SCDOT
South Carolina Department of Transportation
ACCEPTED
X AS NOTED
REVIEWED BY: John Egan 8/22/24
DATE

STATE:	South Carolina
FED PROJ:	Carolina Crossroads Phase 1 & 2
ST PROJ:	P039718
COUNTY:	Lexington & Richland
ROUTE:	I–26 & I–126
SUBJECT:	BOX TRUSS CANTILEVER SIGN SUPPORTS WALPAR STANDARD DESIGN
FOR:	Archer–United Joint Venture
DRAWN BY:	IWL DATE: 8/24/23
CHECKED BY:	RRW DATE: 10/25/23
DWG NO:	C3546–D10

STATE:	South Carolina
FED PROJ:	Carolina Crossroads Phase 1 & 2
ST PROJ:	P039718
COUNTY:	Lexington & Richland
ROUTE:	I-26 & I-126
SUBJECT:	CANTILEVER SIGN SUPPORT ERECTION DRAWING
FOR:	Archer-United Joint Venture
DRAWN BY:	DLK DATE: 9/29/23
CHECKED BY:	DLJ DATE: 10/16/23
DWG NO:	C3546-E10

NO:	REVISIONS	DATE	MADE	CHECKED
1	REVISED PER SPAN INCREASE & ELEVATION CHANGE	7/1/24	DLK	JSD

△1 (16) ~ CLAMP PLATES ~ 67M1

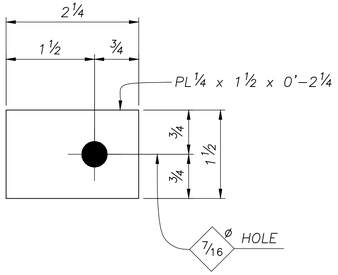
NO:	REVISIONS	DATE	MADE	CHECKED
△1	REVISED QUANTITES PER SPAN INCREASE	7/1/24	DLK	JSD

POST

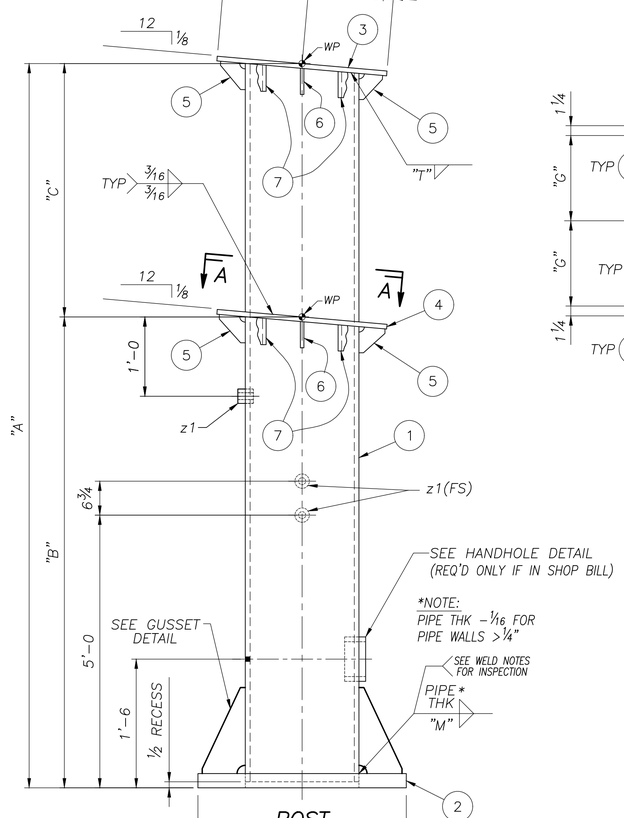
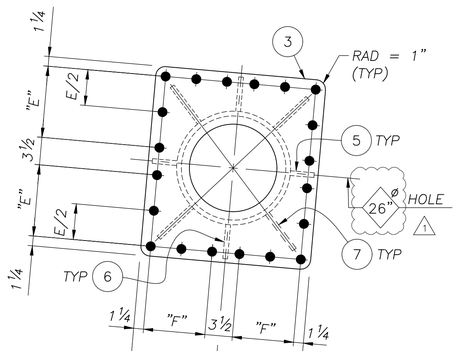
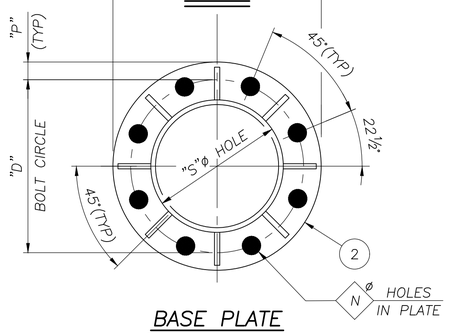
NO:	REVISIONS	DATE	MADE	CHECKED
1	REVISED UPRIGHT POST HEIGHT	7/1/24	DLK	JSD

TRUSS

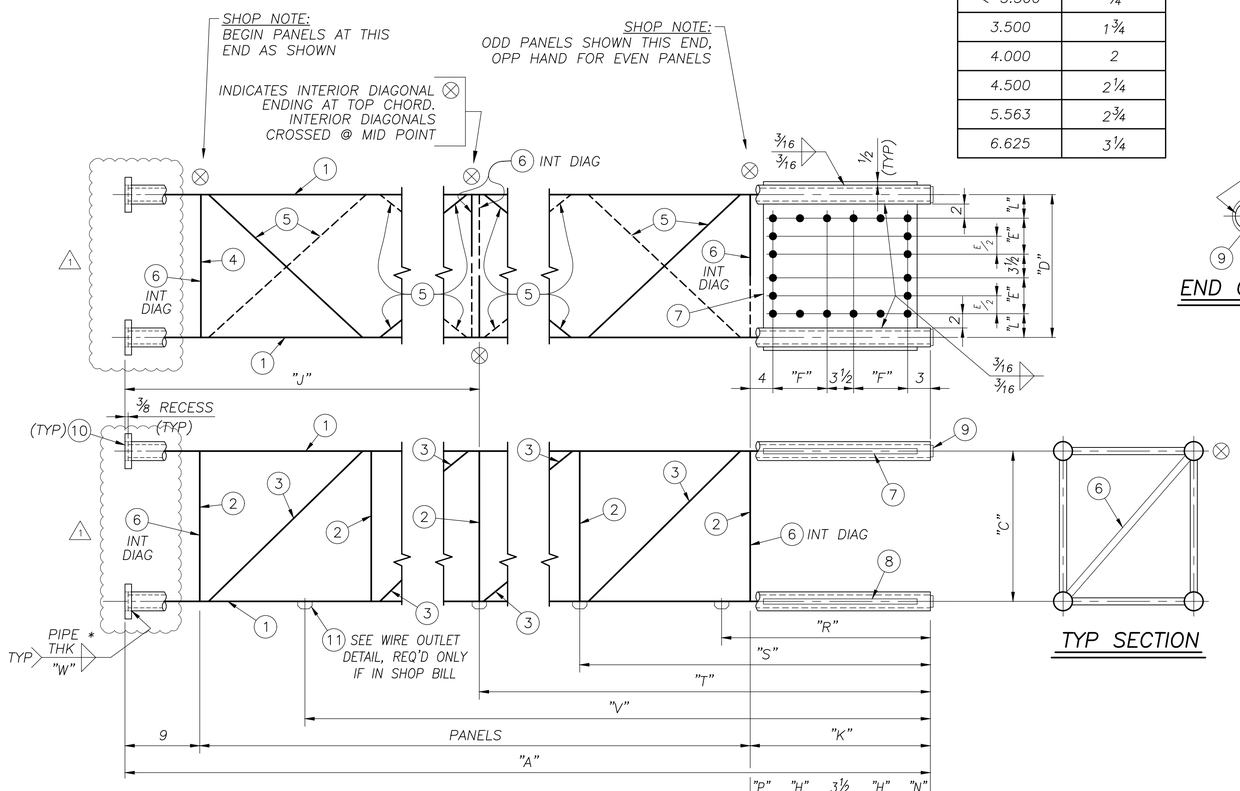
NO:	REVISIONS	DATE	MADE	CHECKED
△1	REVISED PER SPAN INCREASE	7/1/24	DLK	JSD

SIGN/WALK/LIGHT SUPPORTS

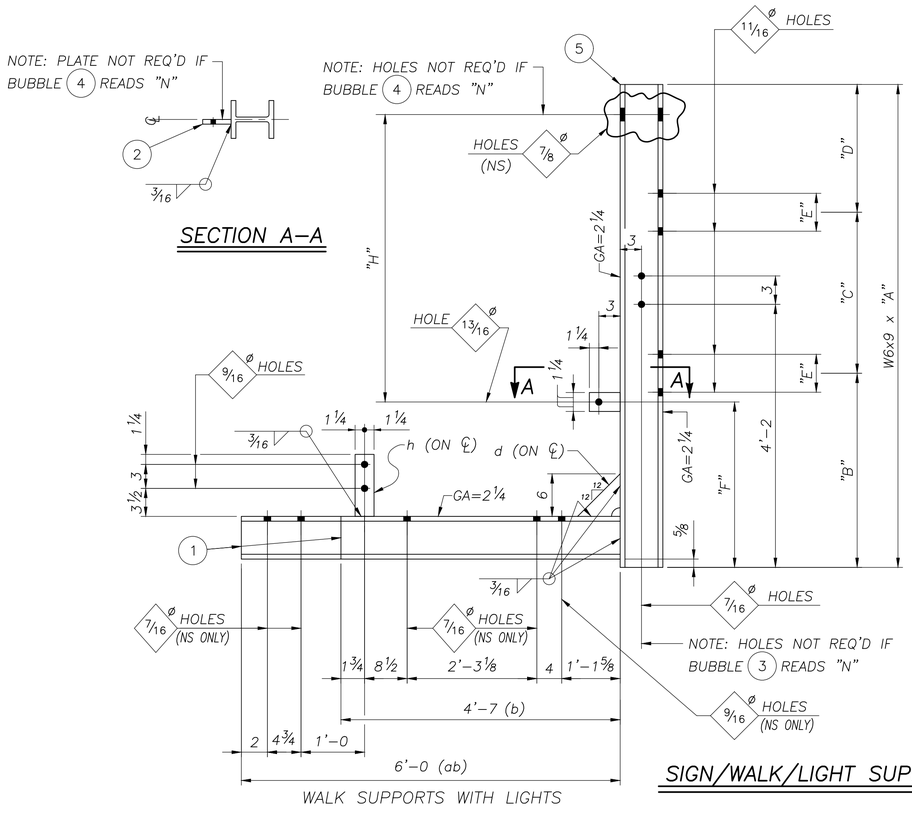
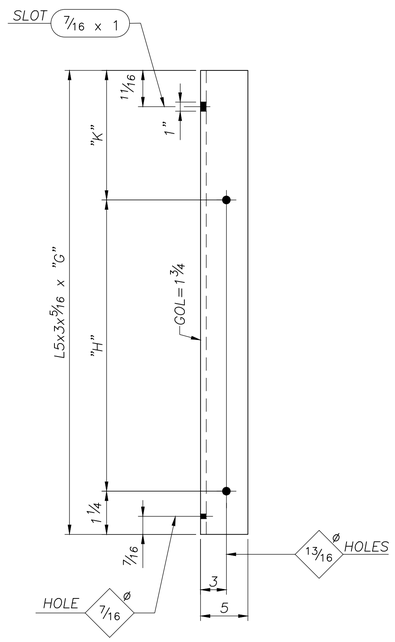
NO:	REVISIONS	DATE	MADE	CHECKED
1	REVISED QUANTITIES PER SPAN INCREASE	7/1/24	DLK	JSD
